Access Compliance Report

Public Rights-of-Way

(Curb Ramps)

Intersection ID: 8814	Main Street: COVECREEK_DR	Cross Street: BURLESON_DR	Location:	S
ADA ID: A44823A3663B	Ramp Type: BlendTrans1	Initial Pass/Fail: Fail	Overall Compliance: No	Severity Score: 1.25
Codes/Mitigation Info/Possible Solution		Field Measurements/Component Compliance

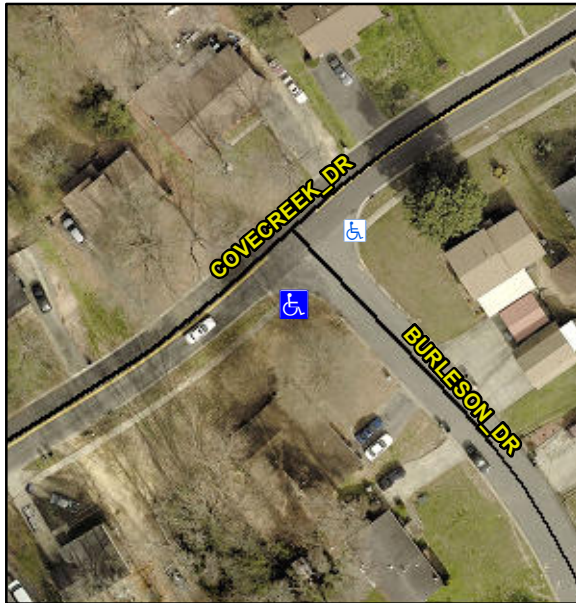
LNDG LIP 1.0

Not Found, R304.5.3

Compliance	Description	Data	Compliance	Description	Data
N/A	Ramp Length (in)	60.5	Yes	BlendTrans Slope (%)	2.8
Yes	Ramp Width (in)	51.5	No	BlendTrans XSlope (%)	3.4
N/A	Flare Type LT	N/A	N/A	Flare Type RT	N/A
N/A	Flare Slope LT (%)	N/A	N/A	Flare Slope RT (%)	N/A
N/A	Flare Traversable LT?	N/A	N/A	Flare Traversable RT?	N/A
N/A	Landing Length (in)	N/A	N/A	DWS Provided?	N/A
N/A	Landing Width (in)	N/A	N/A	DWS Contrast?	N/A
N/A	Landing Slope (%)	N/A	N/A	DWS Length (in)	N/A
N/A	Landing X Slope (%)	N/A	N/A	DWS Full Width?	N/A
N/A	Landing Curb? (Y/N)	N/A	N/A	DWS Offset (in)	N/A
N/A	Shared Landing?	N/A			
N/A	Gutter Ponding?	N/A	N/A	Gutter Slope (%)	N/A
N/A	Gutter Lip Ht (in)	N/A	N/A	Gutter X Slope (%)	N/A
N/A	Painted X Walk1?	No	N/A	Painted X Walk2?	N/A
	X Walk 1 Direction	To NE		X Walk 2 Direction	N/A
	X Walk 1 Width (in)	N/A		X Walk 2 Width (in)	N/A
	X Walk 1 Slope (%)	2.2		X Walk 2 Slope (%)	N/A
	X Walk 1 X Slope (%)	0.2		X Walk 2 X Slope (%)	N/A

N/A	Ramp inside XWalk1?	N/A	N/A	Ramp inside XWalk2?	N/A
	Road Slope (%)	0.2		Clear Space?	N/A
	Road X Slope (%)	2.2	N/A	Clear Space to XWalk (in)	N/A
N/A	Any Obstructions?	N/A	N/A	Storm Grate/Utility Hazard?	N/A
	Obstruction Type			Storm Grate/Utility Type	
		N/A			N/A
			Yes	Surface Condition? (G/P)	Good
			No	Curb Slope (%)	9.7

Remove & Replace Curb Ramp With Two New Directional Ramps or Equivalent.
